Rep → news

07- 2017 July

Standardization Hydraulic Brake Replacement Kits

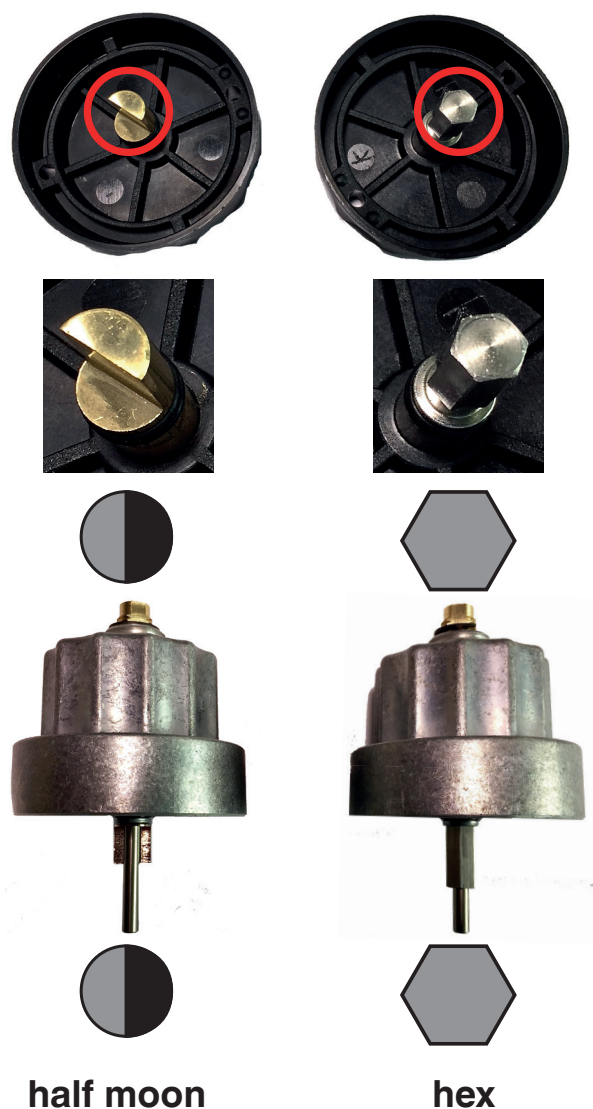
Due to the standardization of the hydraulic brakes we changed the connector shape from "half moon" to "hex".

Please refer to the overview at page 4. There you can find the old Replacements Kits and the new ones for the "hex" version. **Please note the introduction dates.**

Filter Insert Replacement Kit MB-405/407

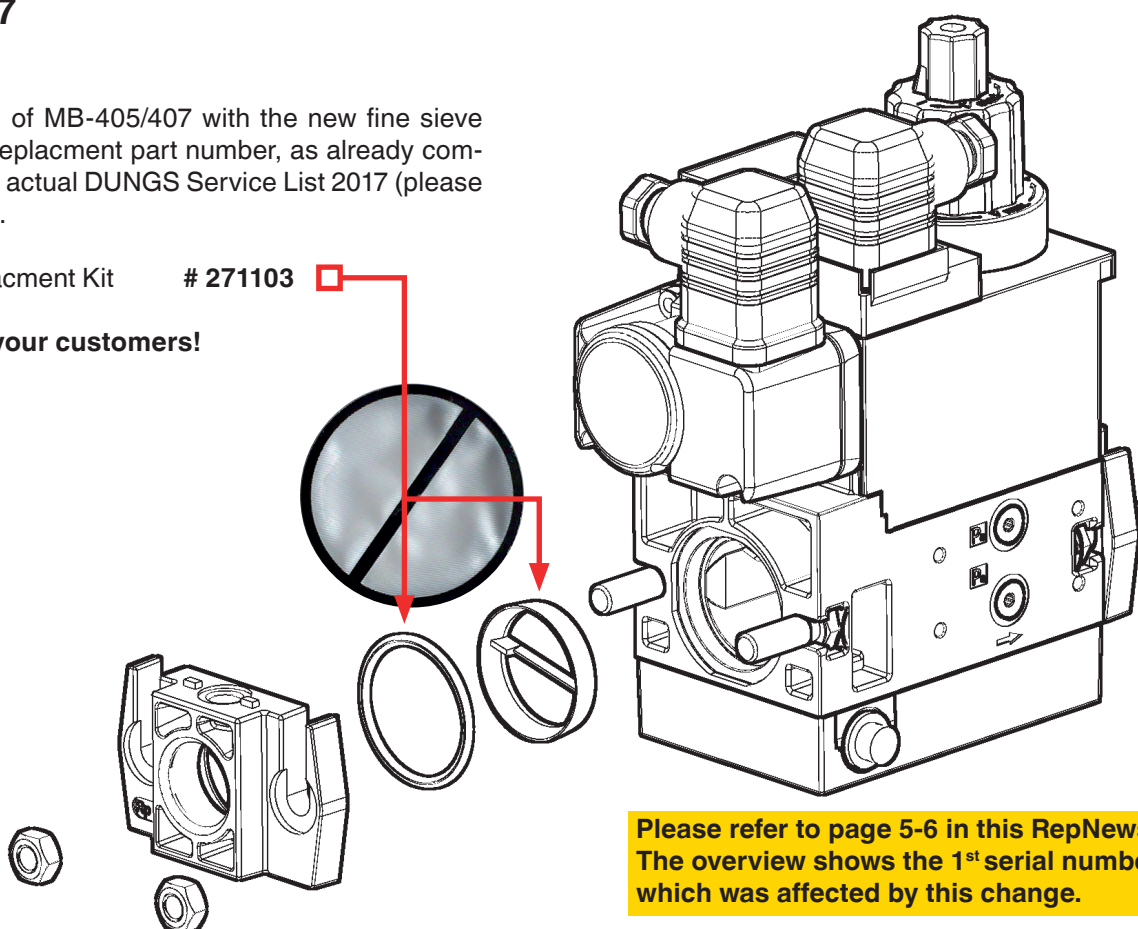
The new design of MB-405/407 with the new fine sieve requires a new replacement part number, as already communicated in the actual DUNGS Service List 2017 (please refer to page 48).

Fine sieve Replacement Kit # 271103
